APPROVED DRAWINGS HAVE BEEN RED LINED INDICATING A CHANGE TO MEET THE OBC. PLEASE REVIEW ALL PAGES TO ENSURE YOU ARE PROPERLY INFORMED OF CHANGES.

**TOWNSHIP OF NORTH DUMFRIES
BUILDING DEPARTMENT**

These Plans have been examined for Compliance with the Ontario Building Code requirements. A Building Permit has been Issued, subject to any changes noted, under the condition that the building will be constructed in accordance with the code.

client: Tice River Homes
 location: Ayr
 project: Legacy
 marketing name:

REAR ELEVATION 'A' & 'B'
(RIGHT)

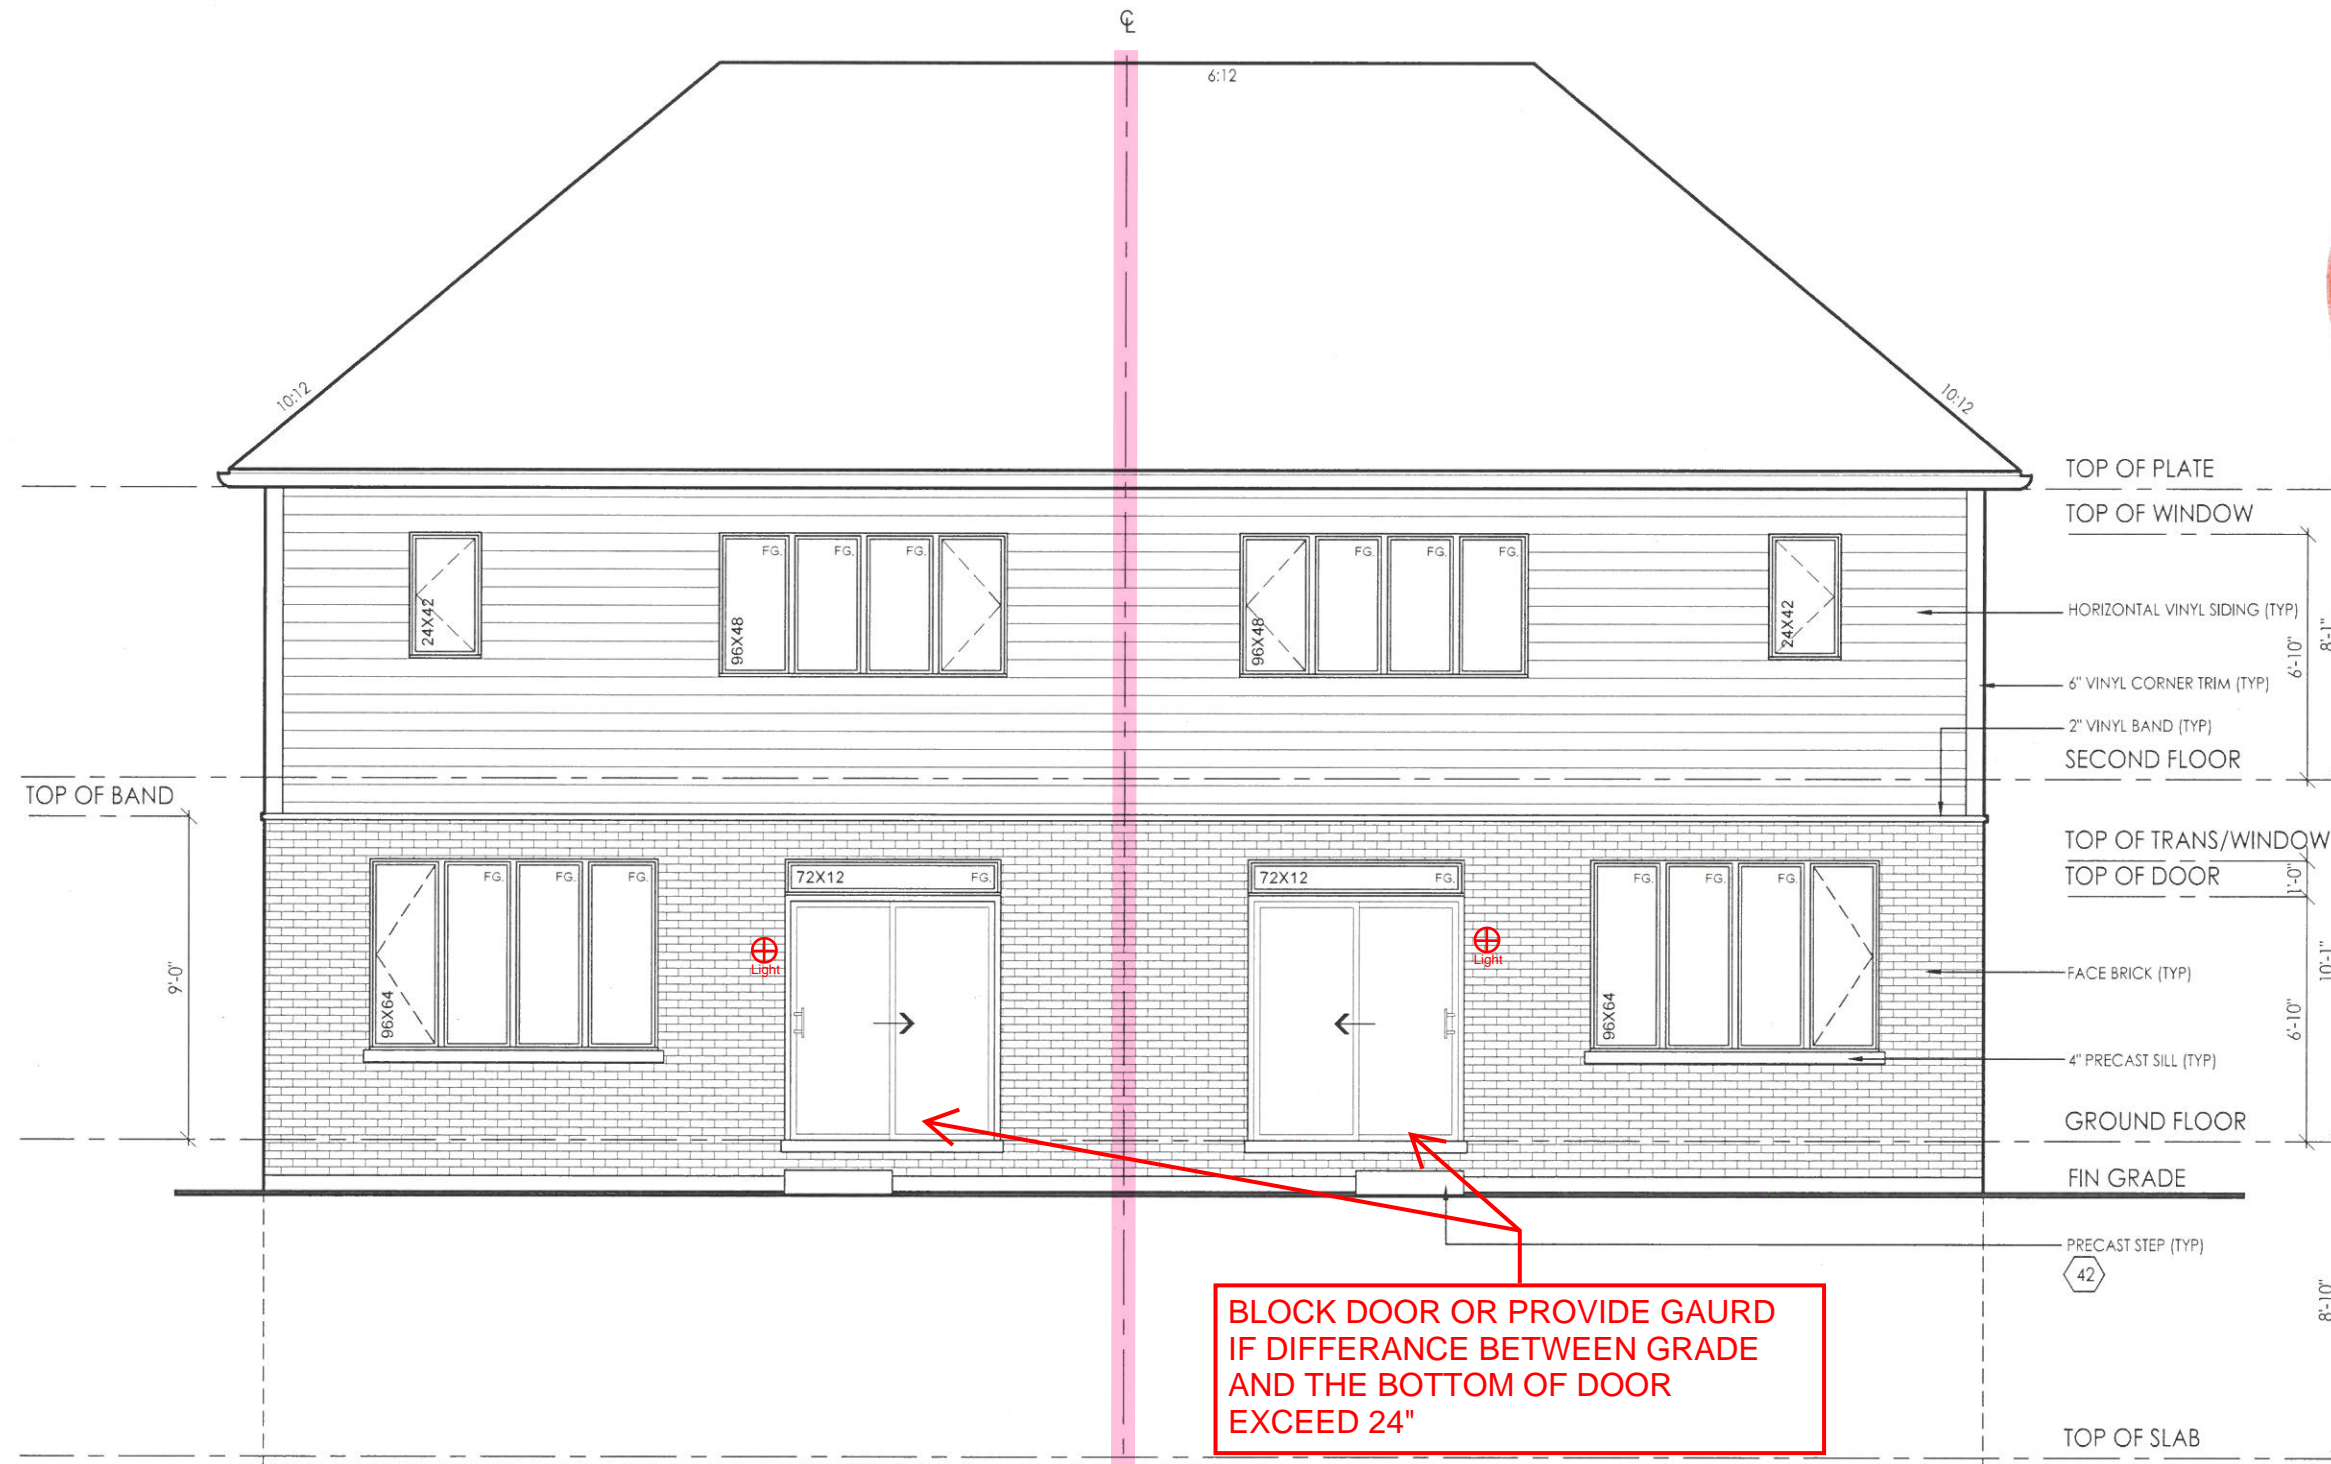
BLOCK DOOR OR PROVIDE GAURD IF DIFFERENCE BETWEEN GRADE AND THE BOTTOM OF DOOR EXCEED 24"
